CITY OF DULUTH – COMFORT SYSTEMS INTERIOR REMODELING
DULUTH, MINNESOTA

ADDENDUM NO. 03

ADDENDUM NO. 3

PROJECT:
City of Duluth Comfort Systems
G&M Project No. 83209

1 POWER AND SYSTEMS PLAN
SCALE: 1/8" = 1'-0"
E4.0

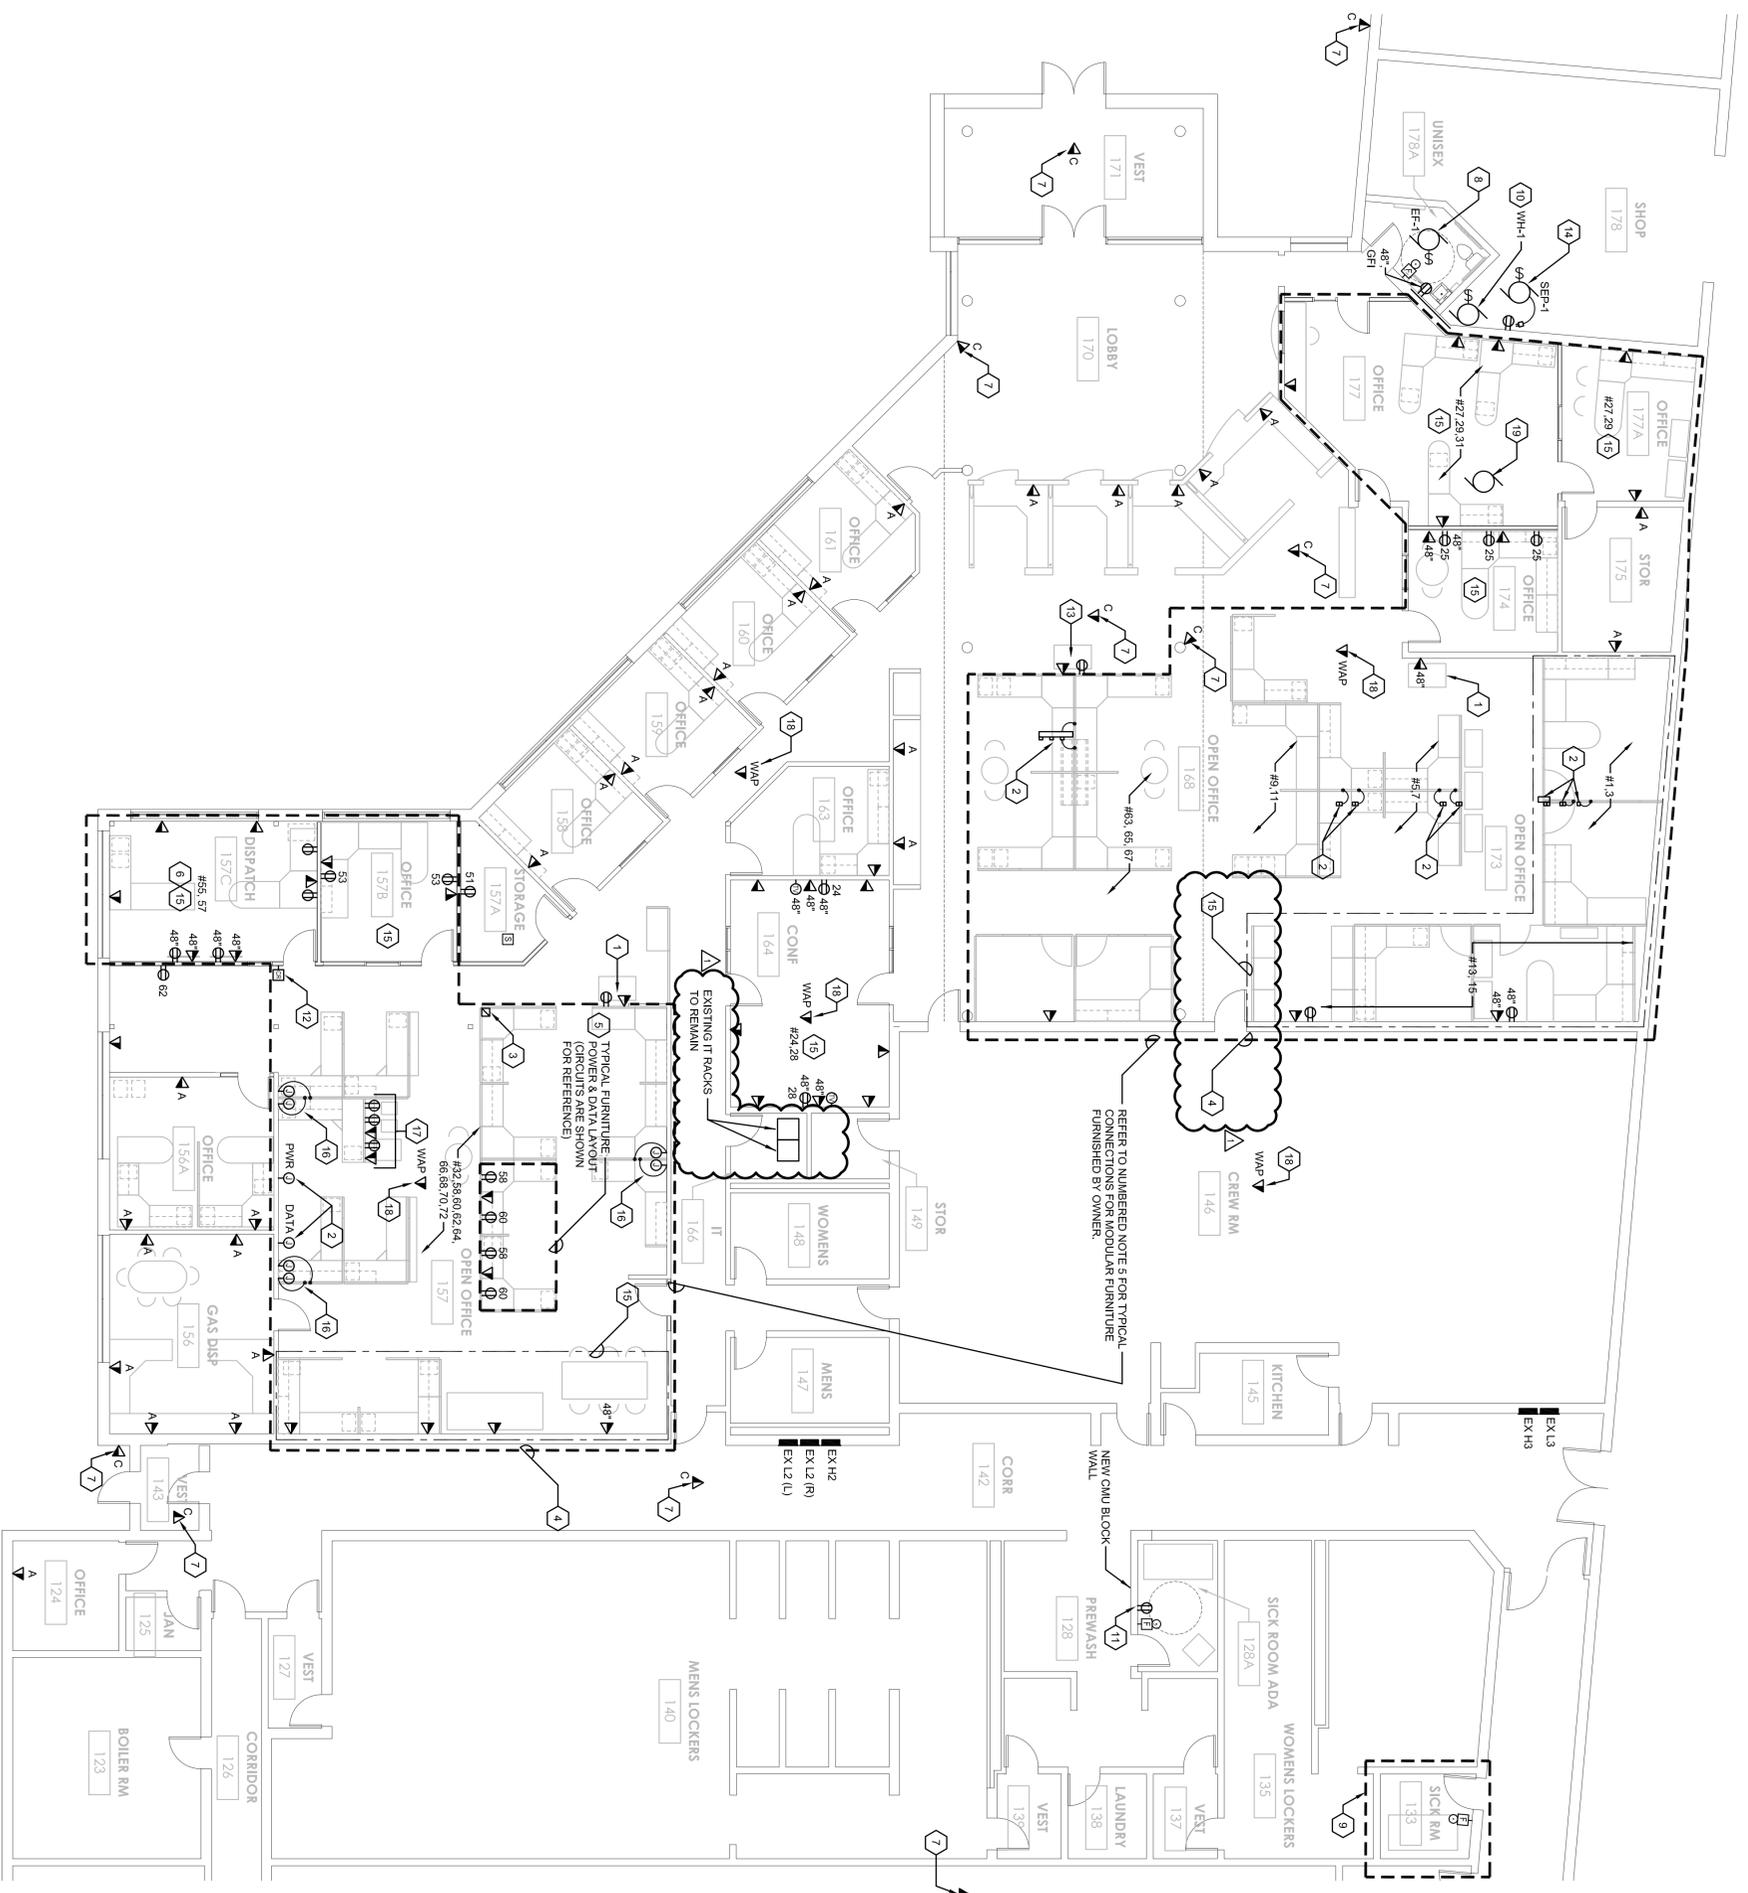
5. SHEET E4.0 Revise numbered notes 5,7,12 and 18 as shown clouded on plan.
6. SHEET E4.0 Delete numbered note 6 associated with existing data rack as shown clouded on plan.

7. SHEET E4.0 Revise numbered note 4 in open office 168 and add numbered note 15 as shown clouded on plan.
